BCA Design Assessment Report

Collaroy Vet Hospital

1121 Pittwater Road
COLLARROY NSW 2097

Project: Collaroy Vet Hospital
 Document Type: BCA Design Assessment Report
 Report Number: P220_451-2 (BCA) LB

Figure 1 Opening on the ground floor requiring protection.

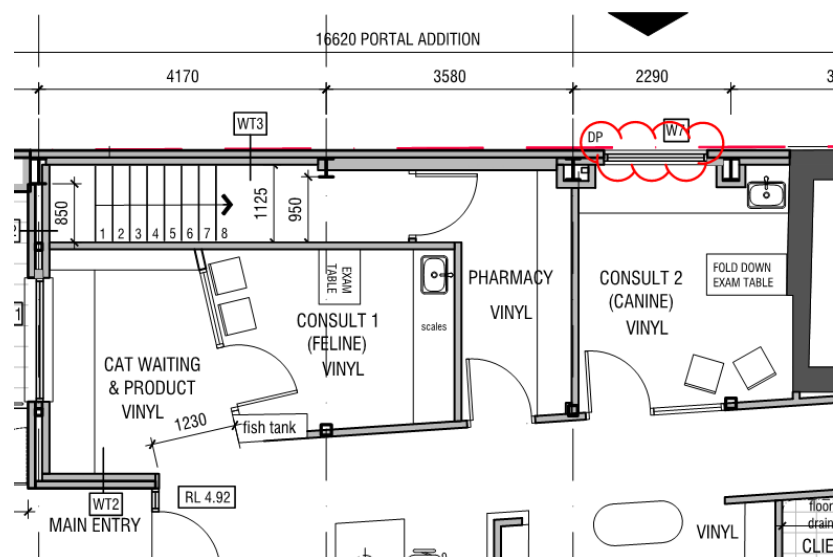
C3.2 The subject development is located on the Northern boundary which is considered a fire-source feature. The boundary walls are required to have an FRL and are proposed to have openings located within.

These openings are required to be protected under the provisions of C3.4, plans note that fire rated glass is proposed to protect the window on ground floor. Doorway on the first floor is to be a self-closing fire door in accordance with C3.4.

Figure 2 Openings within 3m of the boundary on the first floor, clouded new opening requires protection in accord with C3.4

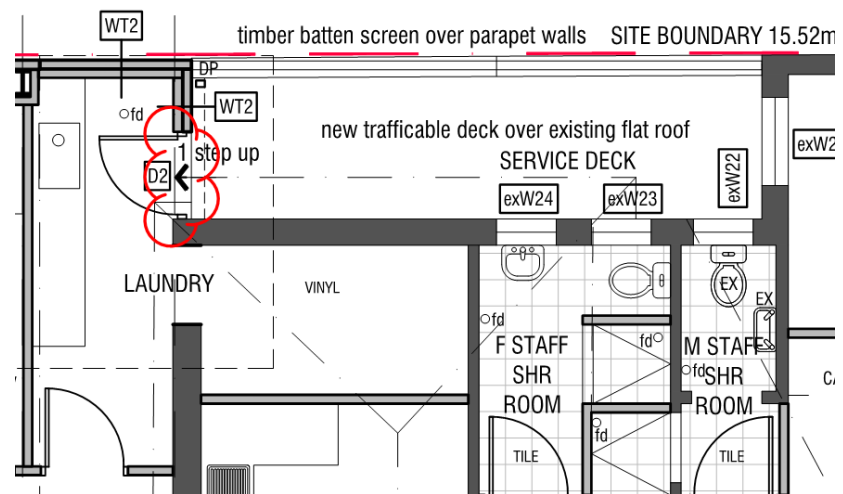
On the first floor, there are existing openings located in theatre 2 and in adjoining shower rooms, as these are existing openings they are considered to fall outside the scope of works.

Figure 3 Extended travel distances on the first floor

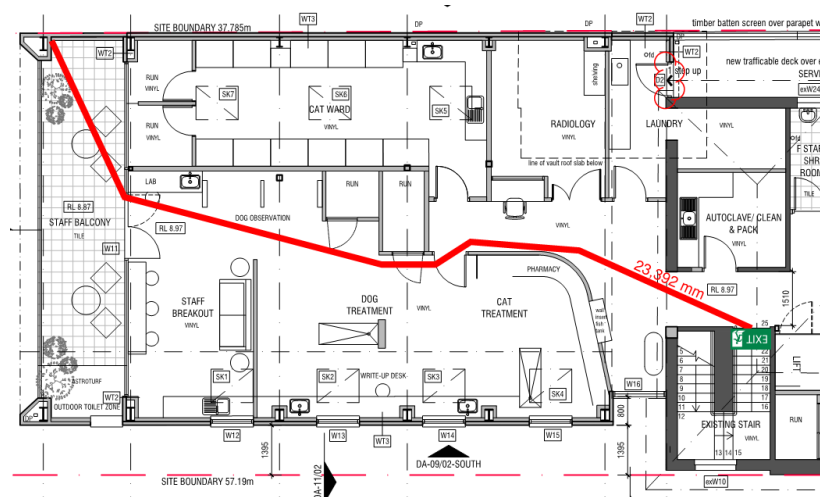
A preliminary assessment of the floor plans has revealed travel distances are exceeded on the first floor up to a maximum of 24m

To ensure compliant travel distances and egress afforded within the tenancy, an additional exit will need to be provided to the storey, or alternatively a performance solution may be sought to assess against the performance provisions of the BCA by a registered fire engineer.
